**Panorama Towers
91-95 John Whiteway Drive
Strata Plan 35094
GOSFORD NSW 2250
28th August 2019**

**Development Application No: 54602/2018
Land Zoned: R1 GENERAL RESIDENTIAL
Property: LOT 1: DP: 45551, LOT: 100 DP: 1075037
No 87 John Whiteway Drive GOSFORD, 89
John Whiteway Drive GOSFORD
Applicant: ADG Architects**

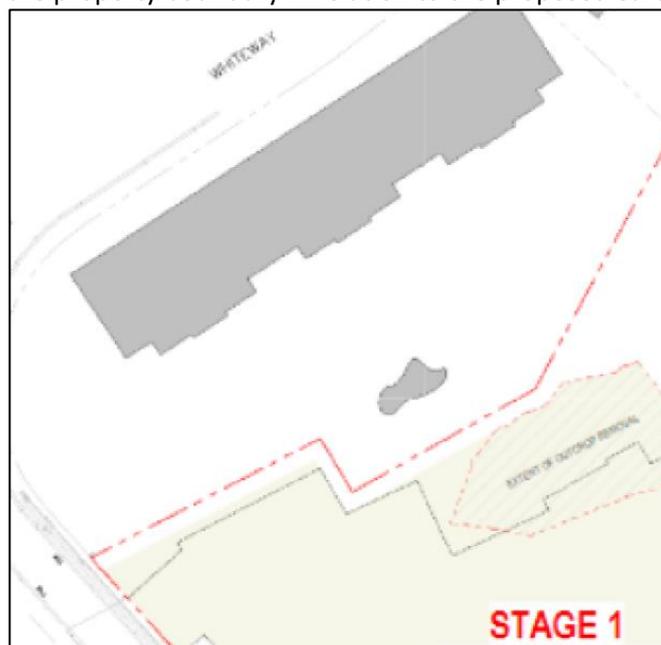
1. This latest amendment to the development application makes no attempt to respect the restriction as to user which applies to the area marked as 'X' on the DP1075037. This restriction is in favour of Gosford City Council, now Central Coast Council.
 - This fact provides the Council with an enormous responsibility to ensure that this proposed development not be permitted within the area marked 'X'.
 - We formally object to Council considering any changes to this restriction in favour of this or any development application. This restriction as to user impacts LEP and DCP height controls including the non-buildable area of the Special area of John Whiteway Drive Precinct. Any

2. This part of the DCP describes the **'buildable area'**, the extent of which coincides with the restriction as to user mentioned above. It clearly identifies the restrictions within the buildable area and the requirements of any development application where variations to the controls may be proposed. It must be reiterated that it refers to **'variations to the designated buildable area'**. Figure 14 of this section of the DCP clearly shows the **'buildable area'** and the remainder of the property which is also clearly shown as a cross-hatched **'non-buildable area'**. The DCP for the Special Area of the JWD Precinct provides only for proposed applications for variations within the designated **'buildable area'**. The absence of any provisions for the **'non-buildable area'** reinforces the fact that the **'non-buildable area'** coincides with the restriction as to user as marked as 'X' on the DP1075037 which is not designated and as such is not open for variation.

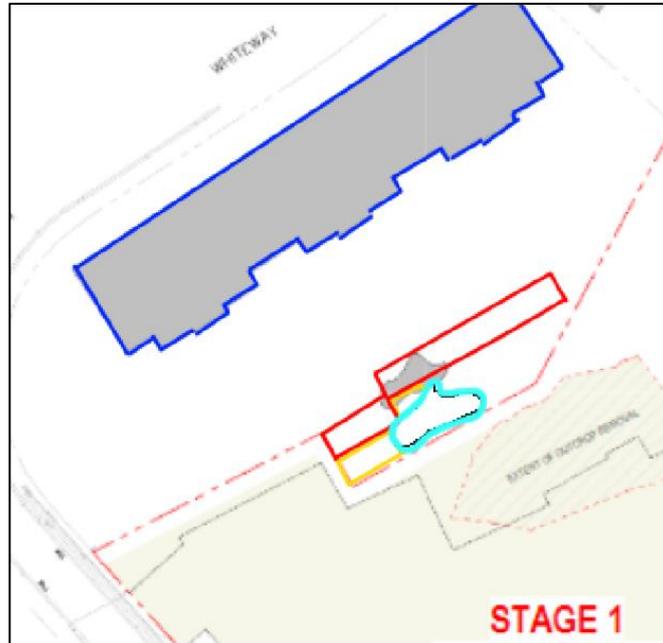
To highlight the risk to our existing development: In the images below, the first image is an extract from the latest notification plans drawing number DA101 – Issue D and shows a portion of the proposed stage 1 earthworks drawing. This image shows the footprint of Panorama Towers building, our swimming pool and the property boundary in relation to the proposed earthworks.

The second image shows the building footprint marked in dark blue, the *actual* position of our swimming pool marked in light blue, the location of below-ground personal property storage marked in yellow and the location of some of the below-ground parking marked in red. In this image it is clear to see the true position of our swimming pool at the base of the vertical cliff face and on the property boundary. Apart from the position of our swimming pool being incorrectly shown on all of the applicant's drawings, it also highlights the potential risk to the structure of our swimming pool, storage areas and vehicle parking.

The third image with aerial photograph clearly shows the swimming pool coincides with the light blue marking and it can be seen that the above-ground vehicle parking structure would also be at risk. It highlights again a consistent error in the applicant's drawings of the position of the building which is shown to be further away than it actually is.

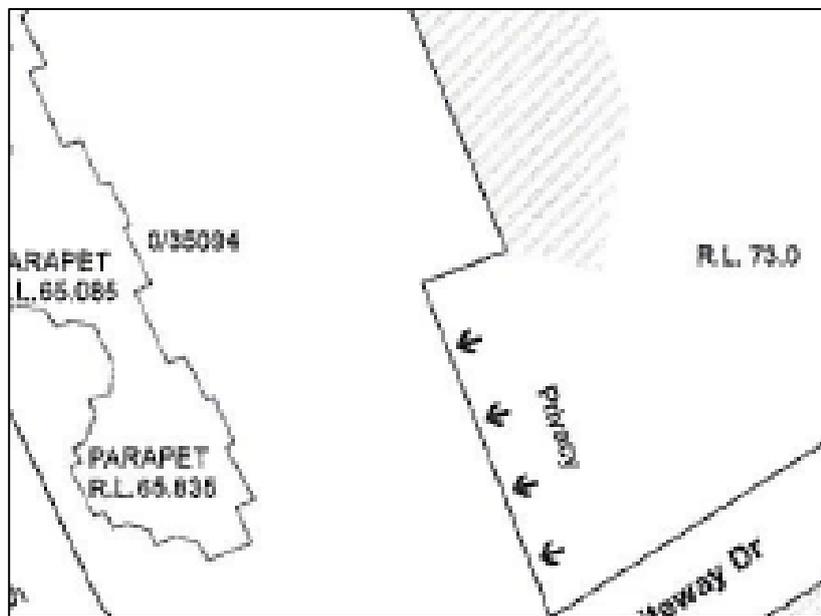
It is claimed that the existing approved height from the previously approved DA is 78.05m, which is already more than 5m above the LEP height controls. If this is correct then the development should have been designed within this limit.

We object to the idea that another variation in height be considered negligible as any additional height would be in addition to the existing 5m in excess of the LEP and DCP controls.

It is also clearly marked on Figure areas where privacy for neighbours should be ensured as can be seen from the extract of Figure 14 below.

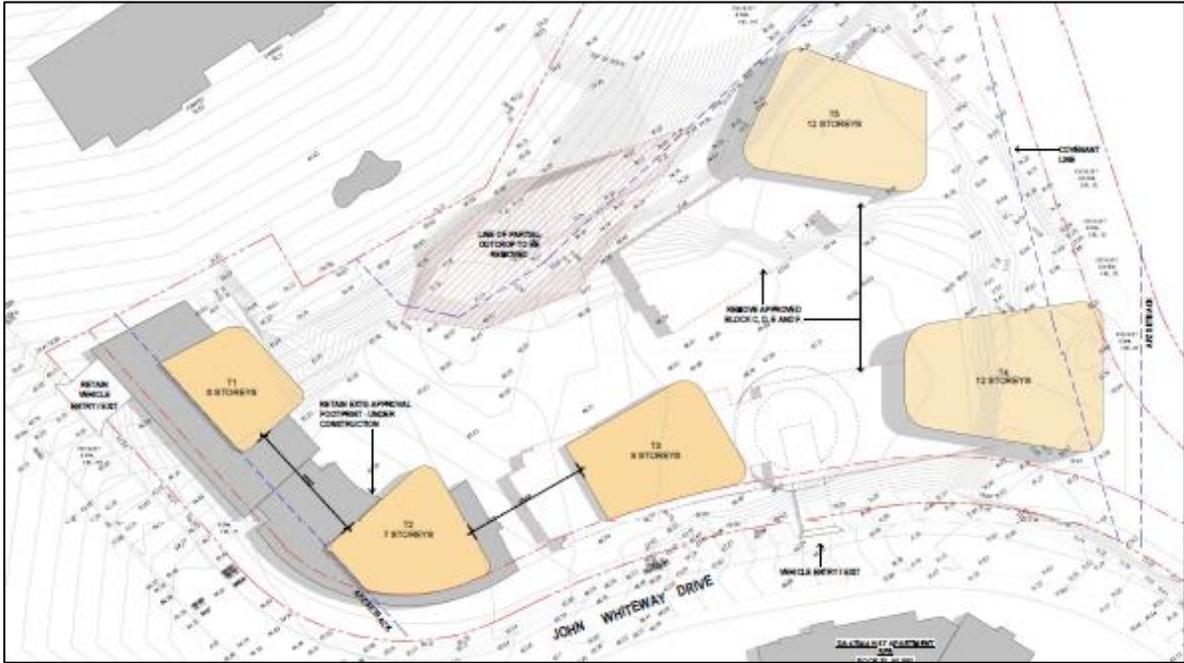
It is with regard to the coincidence of the controls designated as the non-buildable area that we object to this DA in that it chooses to disregard these controls, specifically:
